Microcomputer Technical Information

32-Bit Microcontroller V850E/SV2 Usage Restrictions	Document No.	SBG-DT-04-0045	1/6
	Date issued	February 9, 2004	
	Issued by	Microcomputer Group 2nd Solutions Division Solutions Operations Unit NEC Electronics Corporation	
Related documents V850E/SV2 Hardware User's Manual: U16384E V850E1 Architecture User's Manual: U14559E	Notification classification	<input checked="" type="checkbox"/>	Usage restriction
		<input type="checkbox"/>	Upgrade
		<input type="checkbox"/>	Document modification
		<input type="checkbox"/>	Other notification

1. Affected products

No.3 Restriction when writing to buffer RAM of clocked serial interface (CSIA) with automatic transmit/receive function

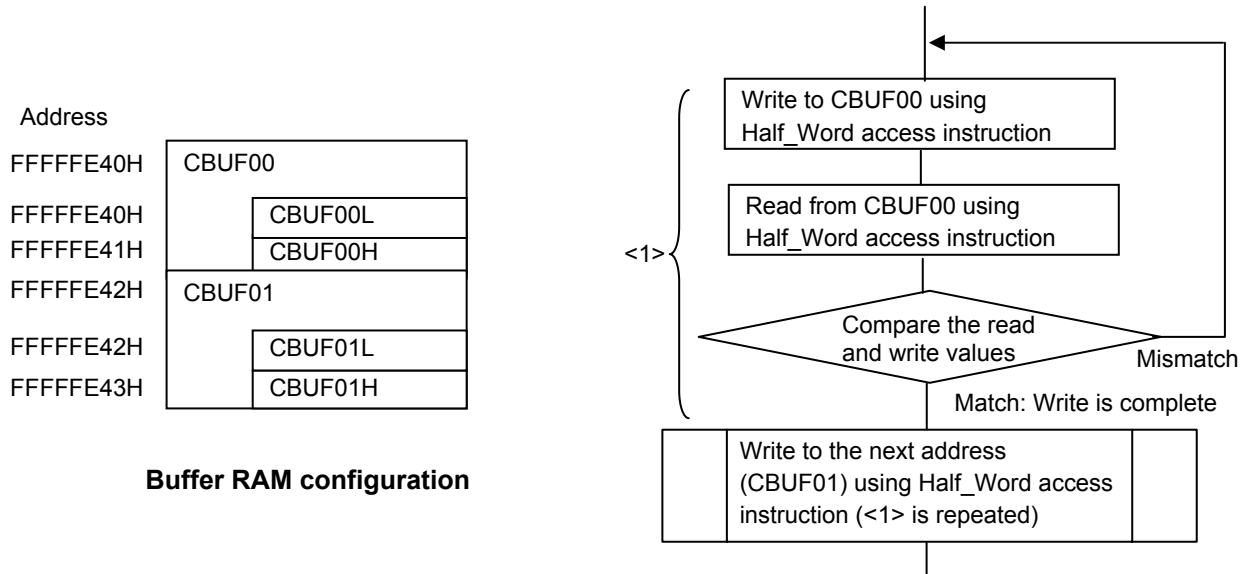
[Description]

When writing transmit data to the buffer RAM (CBUF n m), data may not be written correctly (e.g. Half_Word write is performed even though the Byte access instruction is used, or vice versa ($n = 0$ or 1 , $m = 0$ to 15)).

Implement any of the workarounds shown below by software when writing to the buffer RAM.

Workaround (1)

After data is written, read the data using the Half_Word access instruction (ST.H) and verify the values. If the data do not match, continue writing until the data match. At this time, it is not necessary to disable interrupts.

When writing an odd number of bytes, write dummy data to the buffer RAM (CBUF n mH) at the higher address. ($n = 0$ or 1 , $m = 0$ to 15)

The Half_Word access instruction must be used to access registers until the compare result matches and write is confirmed.

Workaround (2)

Disable interrupts using the DI instruction and write data to the buffer RAM using the Half_Word access instruction (ST.H) only. In addition, re-write the last 2 bytes of the written data again. Do not execute instructions other than NOP and operation instructions (arithmetic, saturate, and logical) between when data is written to the buffer RAM and when the last 2 bytes are rewritten.

Workaround (3)

Disable interrupts using the DI instruction and write data to the buffer RAM using the byte access instruction (ST.B) only. In addition, secure a time equivalent to 5 or more input clocks (f_{SCKA}) selected by bits 6 and 7 (CKSA_{n1} and CKSA_{n0}) of CSISA_n by executing a NOP or operation instruction (arithmetic, saturate, or logical) after the last data is written to the buffer RAM. (n = 0 or 1)

No.5 Restriction on DMA transfer forcible termination

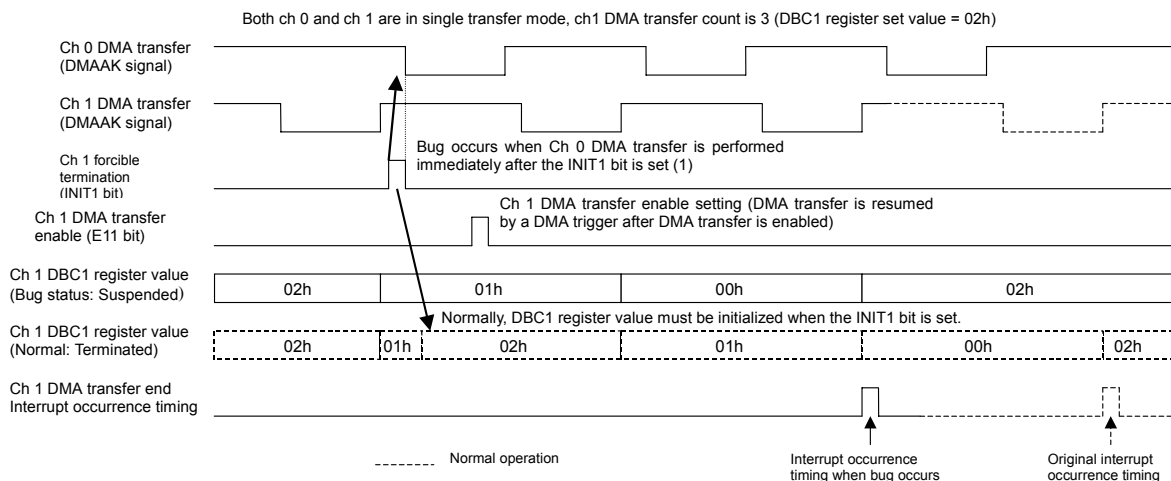
When terminating a DMA transfer by setting the INITn bit of the DCHCn register, the transfer may not be terminated, but just suspended, even though the INITn bit is set (1). As a result, when the DMA transfer of a channel that should have been terminated is resumed, the DMA transfer will terminate after an unexpected number of transfers are completed and a DMA transfer completion interrupt may occur (n = 0 to 3). This bug occurs if a DMA transfer is executed immediately after a forcible termination is set (by setting the INITn bit) (see the figure below).

This bug does not depend on the number of transfer channels, transfer type (2-cycle or flyby), transfer target (between memory and memory, memory and I/O; including internal resources), transfer mode (single, single-step, or block), or trigger (external request, interrupt from internal peripheral I/O, or software), and can occur with any combination of the above elements that can be set under the specifications. In addition, another channel may affect the occurrence of this bug.

The following registers are buffer registers with a 2-stage FIFO configuration of master and slave. If these registers are overwritten during a DMA transfer or in the DMA-suspended status, the value is written to the master register, and reflected in the slave register when the DMA transfer of the overwritten channel is terminated.

The "initialization" in the above figure means that the contents of the master register are reflected in the slave register.

This bug can be avoided by implementing any of the following procedures using the software.

(1) Stop all the transfers from DMA channels temporarily

- <1> Disable interrupts (DI state).
- <2> Read the DMA restart register (DRST) and transfer the ENn bit of each channel to a general-purpose register (value A).
- <3> Write 00H to the DMA restart register (DRST) twice^{Note}.
By executing twice^{Note}, the DMA transfer is definitely stopped before proceeding to <4>.
- <4> Set (1) the INITn bit of the DCHCn register of the channel that should be terminated forcibly.
- <5> Perform the following operations for value A read in <2>. (Value B)
 - (a) Clear (0) the bit of the channel that should be terminated forcibly
 - (b) If the TCn and ENn bits of the channel that is not terminated forcibly are 1 (AND makes 1), clear (0) the bit of the channel.
- <6> Write value B in <5> to the DRST register.
- <7> Enable interrupts (EI state).

(2) Repeat setting the INITn bit until the forcible DMA transfer termination is correctly performed (n = 0 to 3)

- <1> Copy the initial transfer count of the channel that should be terminated forcibly to a general-purpose register.
- <2> Set (1) the INITn bit of the DCHCn register of the channel that should be terminated forcibly.
- <3> Read the value of the DMA transfer count register (DBCn) of the channel that should be terminated forcibly and compare the value with the one copied in <1>. If the values do not match, repeat <2> and <3>.

No.6 Restriction on DMA transfer forcible suspension by NMI

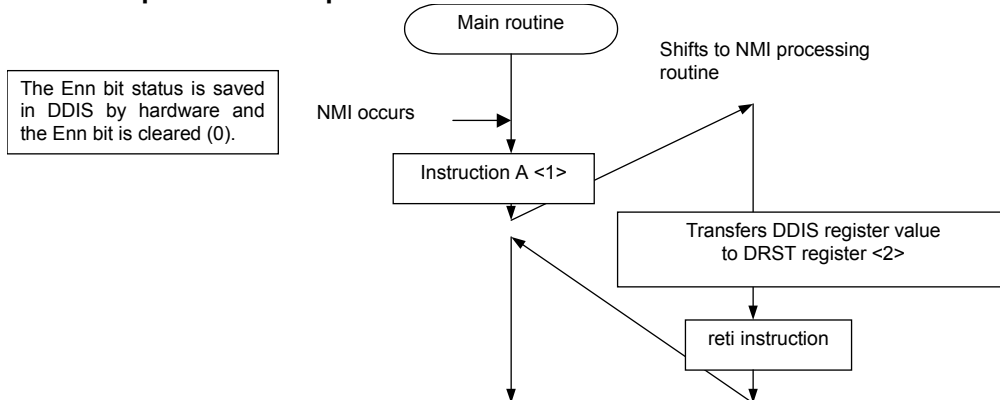
DMA transfer is forcibly suspended by an NMI input during a DMA transfer. At this time, the DMA controller saves the status of the Enn bit (bit 0 of the DCHCn register) of all the DMA channels to the DDIS register, clears (0) the Enn bit, and disables the DMA transfer. In addition, when an NMI interrupt is acknowledged in the CPU pipeline operation, an instruction that has already been fetched is executed (1 instruction max.).

If this instruction is the one used to manipulate the Enn bit, the contents of the DDIS register are transferred to the DRST register in the NMI processing routine in order to resume the suspended DMA transfer. Therefore, the Enn bit setting immediately after the NMI input is not reflected.

As a result, the DMA transfer suspended by the NMI input cannot be restored as expected regardless of whether DMA transfer has been disabled or enabled.

Operation Example

When the Enn bit of the DCHCn register is set to disable or enable DMA using instruction A, the disable/enable status of each DMA channel is inconsistent in <1> and <2>. As a result, the normally suspended DMA transfer cannot be restored correctly.

Furthermore, when the Enn bit is set (1) using instruction A while the software trigger bit (STGn) of the DCHCn register is set (1), DMA transfer is performed even in the NMI processing routine.

Initialize the DMA transfer forcibly suspended by the NMI and then execute it again.
